# AG-CAT SERVICE NOTES and BULLETINS

**GRUMMAN** AMERICAN AVIATION  
CORPORATION

AG-CAT SERVICE BULLETINS

## SERVICE BULLETIN INDEX

DETAIL & INSTALLATION OF A1549-5<sup>(1)</sup> STOP SHALL BE AS SHN BELOW:

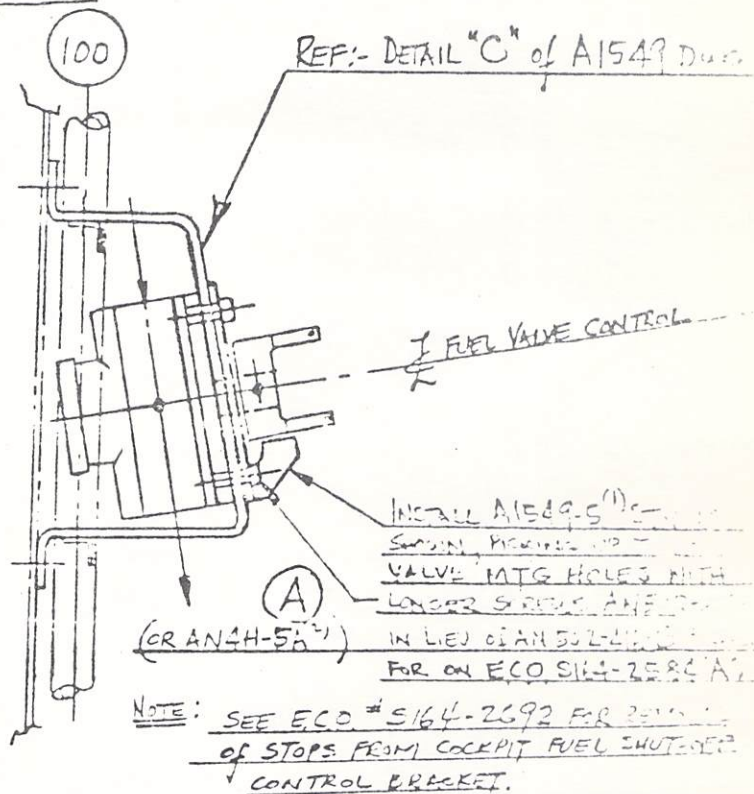
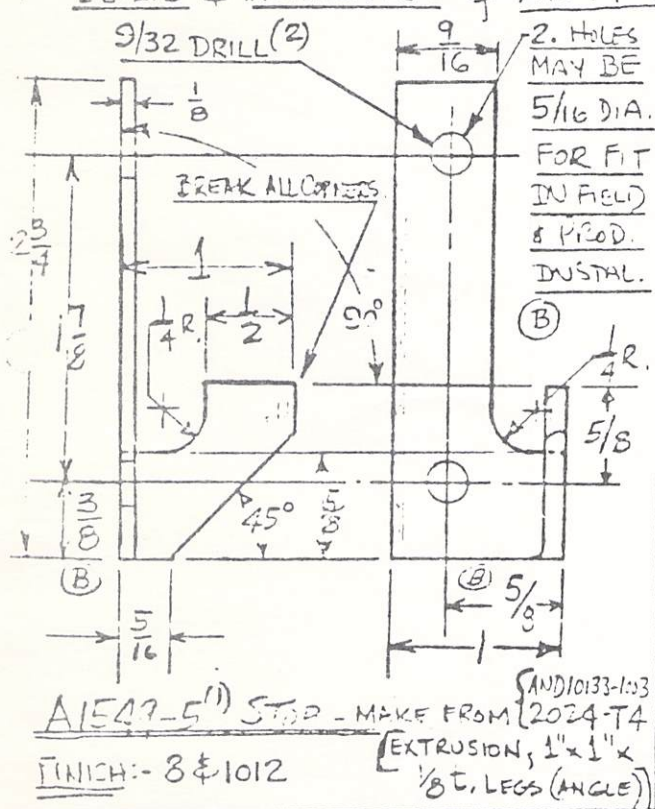
CHANGE: 1. ADD A1549-5<sup>(1)</sup> (STOP) TO A1747-1 (3/4" P.T. PORT VALVE INSTALL. 5/8" D. GRAVITY-FLOW FUEL SYSTEM) AS SHOWN ON DETAIL "C" OF DWG A1549.
